May 13, 2021

RE: Reply to Renewal Application dated March 3, 2021 (Mail Control No. 624964)
District Hospital Partners, L.P. d/b/a The George Washington University Hospital
License: 08-30607-01

Area Closeout Survey Report

**George Washington University Hospital
Ambulatory Surgery Center (Basement)
2021 L Street, NW
Washington, DC 20037**

Figure 1 – Ambulatory Surgery Center (basement)
2021 L Street, NW
Washington, DC 20037

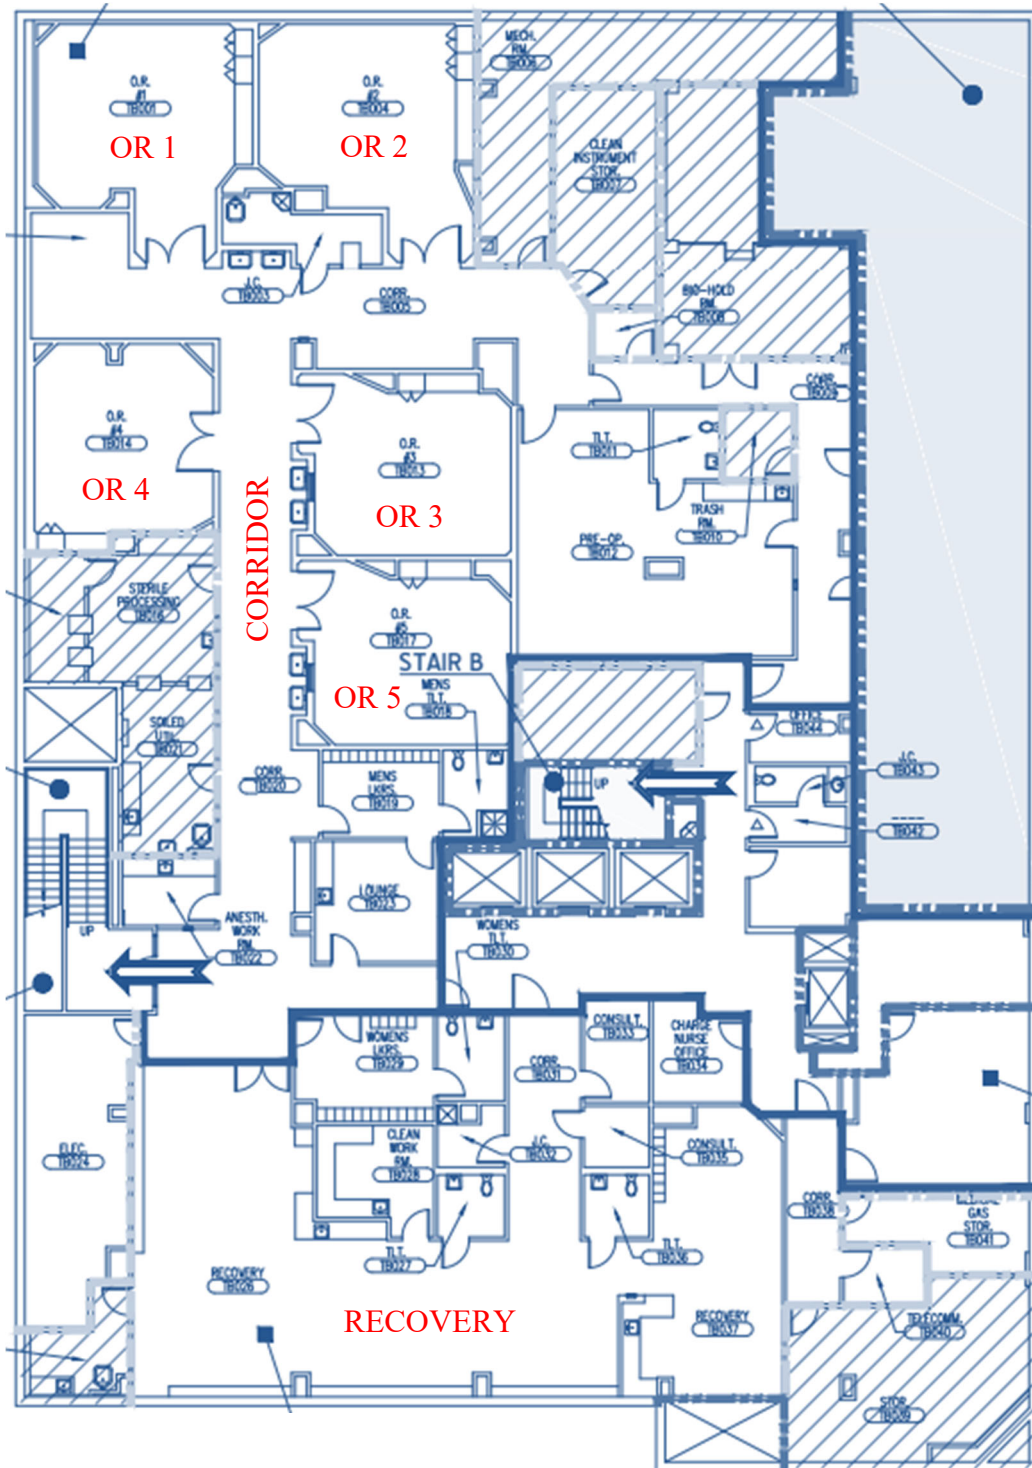
Item 1. *You have requested The Ambulatory Surgical Center (basement), 2120 L Street, N.W., Washington, D.C. be removed as a use location from your license. Please submit documentation of the historical use of licensed materials in the Ambulatory Surgical Center and the radiological assessment confirming no residual contamination remains, or provide a justification why such assessment is not necessary (i.e. no licensed materials were used in the facility) to release the areas from unrestricted use.*

Response: The Ambulatory Surgery Center located in the basement of 2120 L Street, N.W. was previously used for brachytherapy treatments. Treatments were restricted to the use of I-125 only in the form of sealed sources (seeds). Seeds were placed in patients for treatment in any of the five operating rooms in the surgery center. Patients were transferred post-op to a recovery area before being discharged from the use location. The brachytherapy program ceased performing treatments prior to 2013. No incidents of lost or transected seeds are on record under this program. Per routine quality assurance checks performed by Radiation Oncology under the brachytherapy program, sources were meticulously accounted for before, during and after treatments. An area closeout survey was performed for this use location on May 12, 2021 and a report of this survey is enclosed. This report indicates that no residual contamination remains, and exposure readings are at background levels. This use area has been deemed suitable to be released for unrestricted use.

The Ambulatory Surgery Center encompasses the basement floor of the above-cited address. The areas where radioactive material was used consisted of 5 operating rooms and a patient recovery area. A floor plan of the facility is included at the end of this report in Figure 1.
